Product / Process Change Notification

PCN #: Affected Series: BPS 1W and 3W PCN Date: 2021-05-19 Effective Date: 2021-01-05		☐ Equipment / Location ☐ General Data ☐ Material ☐ Process ☐ Product Design ☐ Shipping / Packaging ☐ Supplier ☐ Software
Contact: iseg Spezialelektronik GmbH Phone: +49 351 26996-0 E-Mail: support@iseg-hv.de		Data Sheet Change: ☐ YES ☐ NO Attachment: ☐ YES ☒ NO
DESCRIPTION AND PURPOSE OF THE CHANGE: Changed distances of the connections to the module edge.		
DETAIL OF CHANGE: Before change:

Figure 1

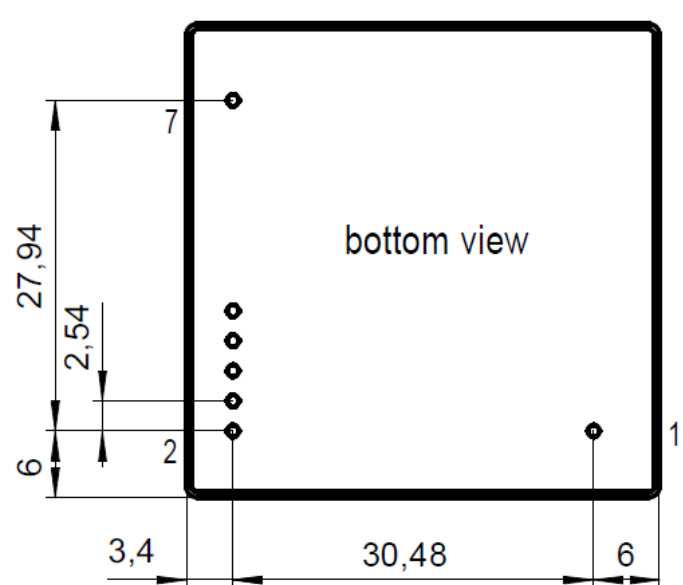
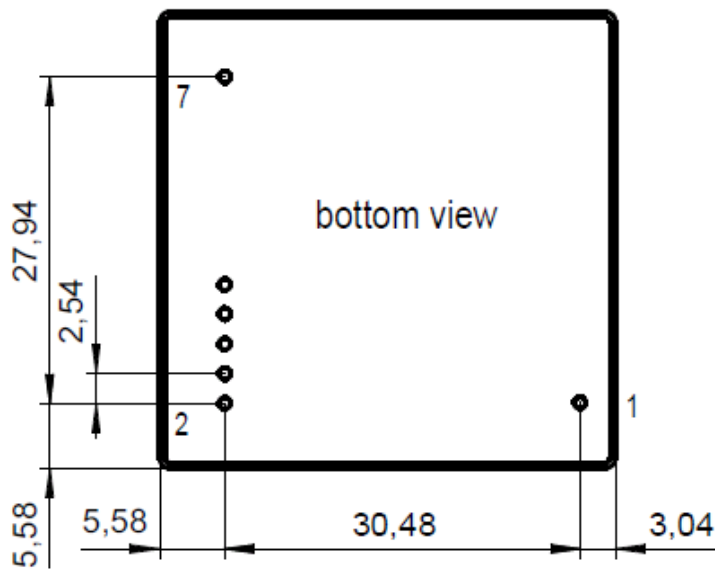
There was no change in the dimensions of the BPS module. For technical reasons, the dimensions are only specified more precisely in the new module.

The modules of the BPS series 1W and 3W are listed under a new item code: BP yyyyyy x yy **A0**
